**ROCKY FORK-BLACKLICK ACCORD IMPLEMENTATION PANEL**

## THE ROCKY FORK-BLACKLICK ACCORD STAFF REPORT

**Z26-016 & CV26-042 (7665 Harlem Rd)**

Conceptual review regarding a Columbus rezoning and concurrent council variance application for multiunit residential located at the southwest corner of Harlem Rd and Walnut St,

**SITE PLAN**

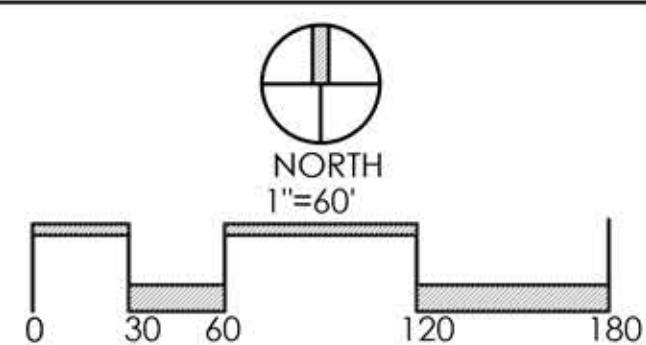
Staff find the proposed use to be appropriate based on location and surrounding development patterns to the west and south. Staff note the proposal is consistent with the Rocky Fork Blacklick Accord development standards and is compatible with surrounding residential development. Staff note the proposal clusters development to the north to accommodate the Future Hamilton Rd Extension right-of-way and preserves natural resources within the floodway of the Rocky Fork.

Staff request naturalized stormwater facility with no fountain, potential for wetland shelving, and a naturalized shape. Staff request dedication of the remnant portion of floodway/creek to Columbus Recreation and Parks holdings and discussions for a greenway buildout. Staff request trees along the future Hamilton Rd right-of-way that would supplement eventual street trees along the frontage. Lastly, staff request sidewalks/share-use-paths along the Walnut Street frontage and Harlem Rd frontage where there is no overlap with future Hamilton Rd right-of-way.

3.1.2 Maintain major stream corridors in their natural state or allow such state over time.	√		Floodway/SCPZ protected on site plan
3.1.3 Construct pathways through stream corridors.		√

3.1.4 Rural road open space should be left in its natural wooded state, be allowed to revert to that state, or remain as farmland or grassland.		√	Walnut St classified as Rural Road. Existing site is agricultural use. Site plan proposes street tree plantings.

3.2.3 Landscaping within the setback along roadways should appear natural in character.	√		
3.2.4 Site layout should avoid unnecessary destruction of wooded areas. Attempt to preserve existing trees and tree rows.	√		Site is agricultural in nature for the developed area. Staff encourage preservation of existing tree line within western perimeter yard.

3.2.5 Landscape designs reviewed by registered landscape designer or architect.	√		
3.2.6 Headlight screening in parking lots a minimum of 4 feet.	√		Parking hidden to the rear of buildings.

3.4.1 Roadways should follow the Roadway Plan.	√		Proposed 100' ROW for Walnut St and reserves Future Hamilton Rd Extension ROW
3.4.2 Appropriateness of street light fixture, type, and light level of the luminaire.	√		Most likely will happen

# 3-STORY BUILDING ELEVATION- TYPE L

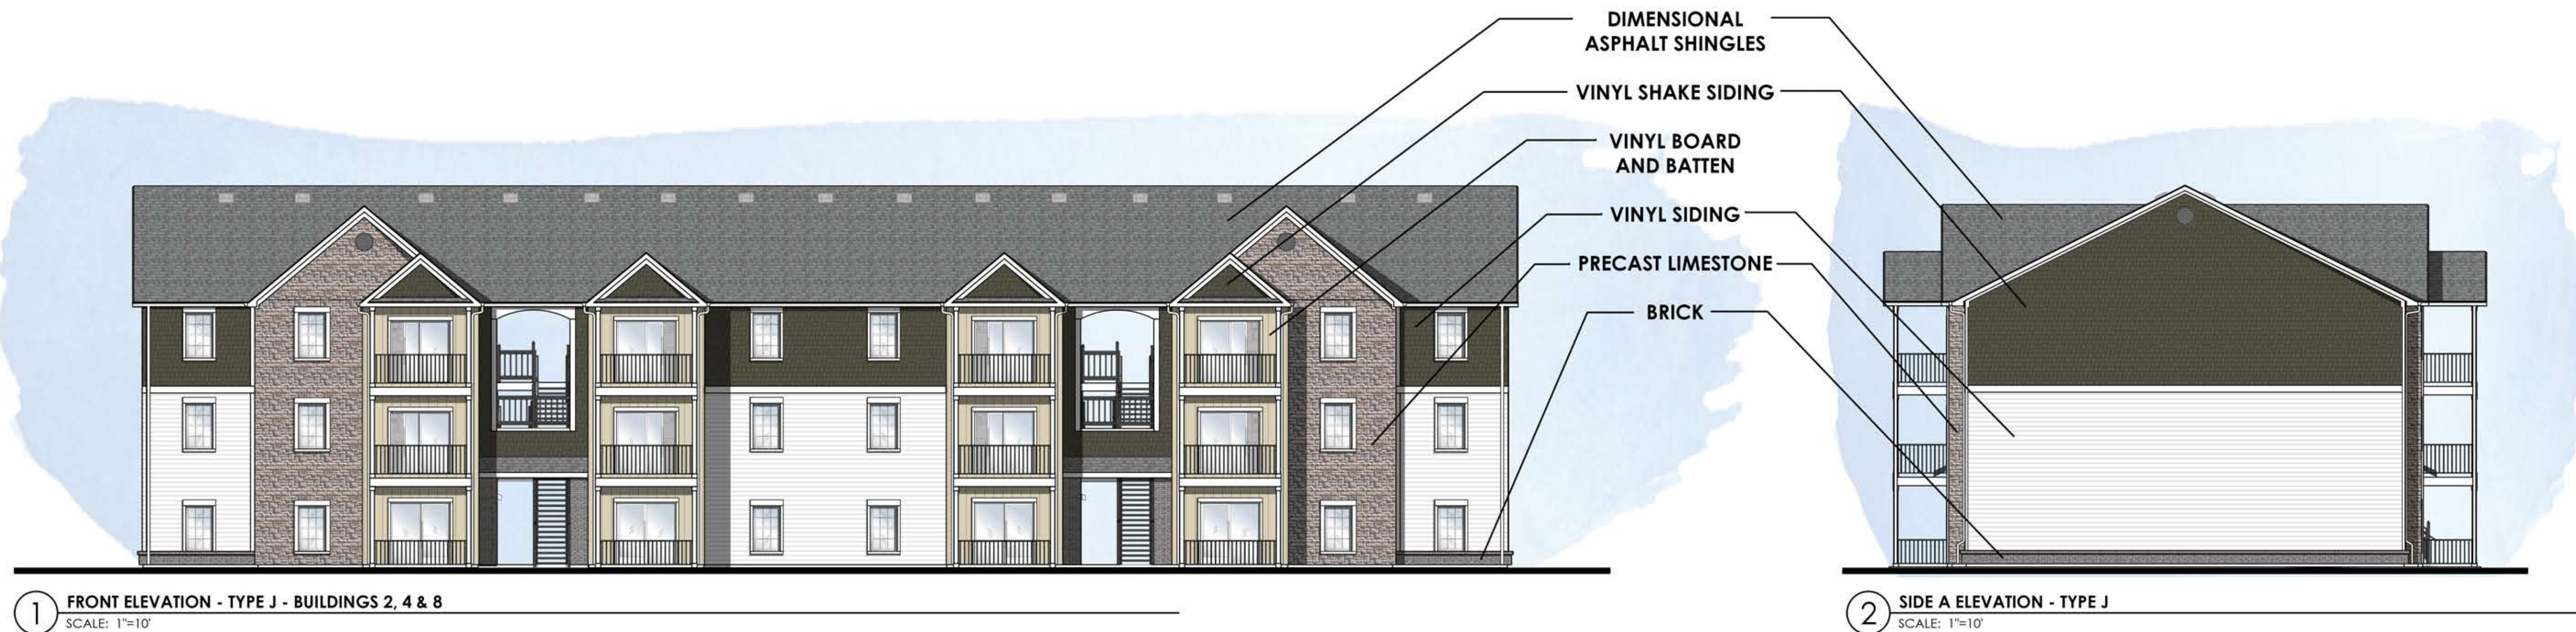
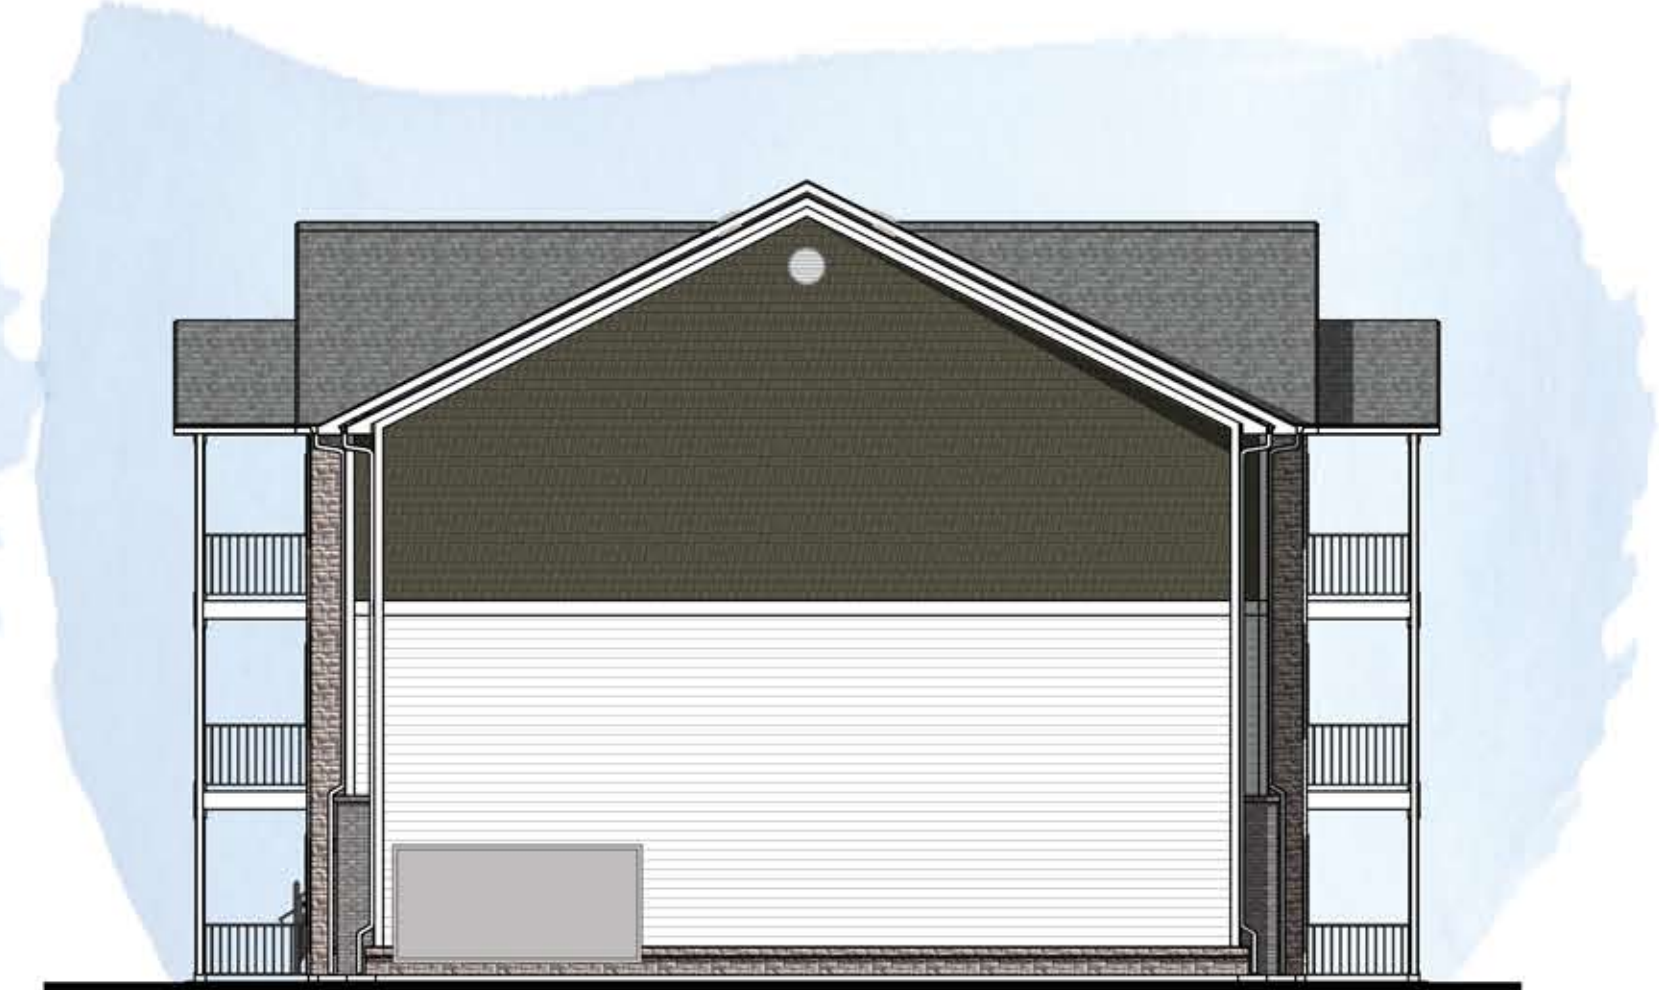
4.6.2 Sloped and pitched roofs are encouraged. Flat roofs are allowed only with highly detailed or decorative cornices.	√		Sloped and pitched roofs provided

4.6.4 The maximum width of a garage door which faces the street is ten feet.	-	-	
4.6.5 Building materials should be traditional and natural in appearance, such as brick, stone, wood, and glass.	√		Materials proposed include, Brick, Precast Limestone, Vinyl Board & Batten, and Vinyl Siding

4.6.6 The maximum building height should be two and one-half stories and the minimum building height should be one and one-half story in appearance.		√	Proposed 3 story buildings
